PULTE GREENWOOD

ADMINISTRATIVE DESIGN REVIEW | SDCI #3034268-LU | 26 JUNE 2020

Board Recommendation - 2.c.ii

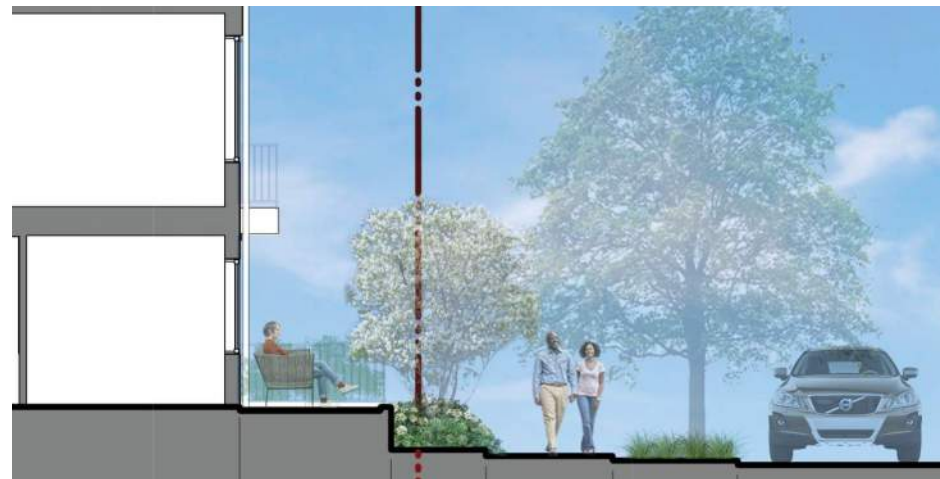
- ii. The Board stated that the centralized internal driveway should be scaled appropriately to accommodate space for potential landscaping treatment and provide space for potential modulation of the units and articulation of any entries that may occur along that space. The Board requested that this Board direction is addressed in the next design packet. (PL1.B, PL3.A, PL3.B.2, DC1.B.1, DC1.C.2, DC2.A.1)

Central driveway scaled for landscape treatment and unit modulations (PL1.B, PL3.A, PL3.B.2, DC1.B.1, DC1.C.2, DC2.A.1)

The access point to the centralized driveway is lined with landscaping along the North side of the drive while the Southern edge is a distinctly paved pedestrian accessway. The pedestrian paving continues to the western edge of the property through the site. The paving pattern creates a distinctive pedestrian zone throughout the project. The expectation, with the change of paving at this point, is to create a more inviting environment safe for pedestrians, as well. Overhead lighting and awnings are used in this region, as well, to encourage use of the space. While all entry doors have been eliminated from this zone, the use of the space is still encouraged through lighting, overhead protection and paving.

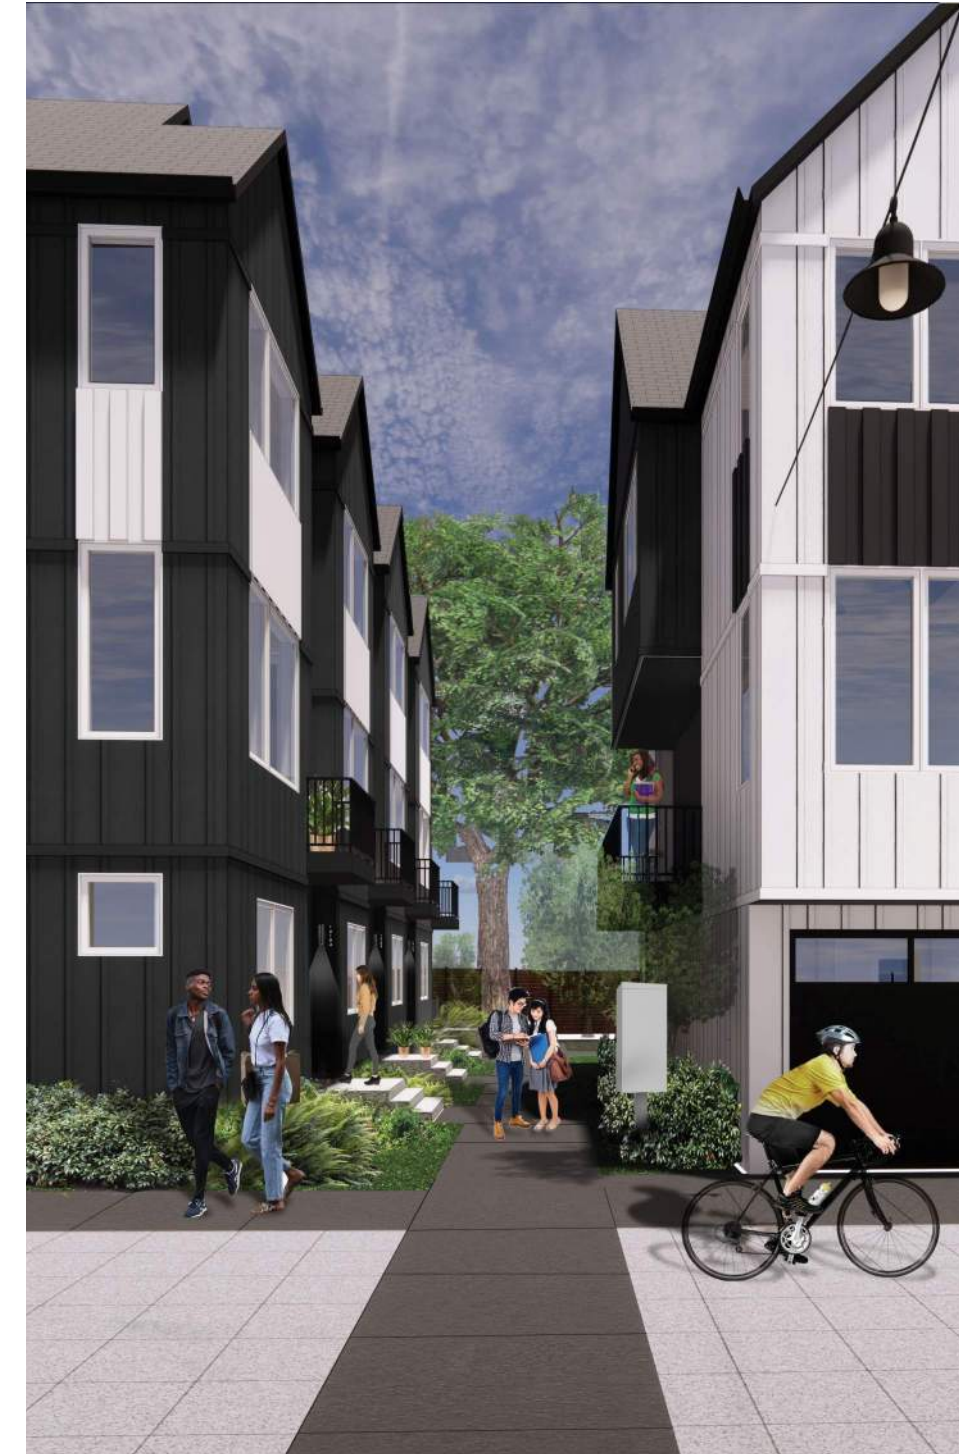
Exterior waste/recycling storage compliments materiality, aesthetics and scale of the development (DC1.B.1, DC1.C.4)

The screening elements at the waste/recycling storage locations are proposed to be wood siding with black framed elements and details. The wood is proposed as a warming element to compliment the surrounding green screens and black and white siding. The orientation of the enclosures have been modified to create a through passageway for safety and ease of use. The proposed layout has been approved by SPU.
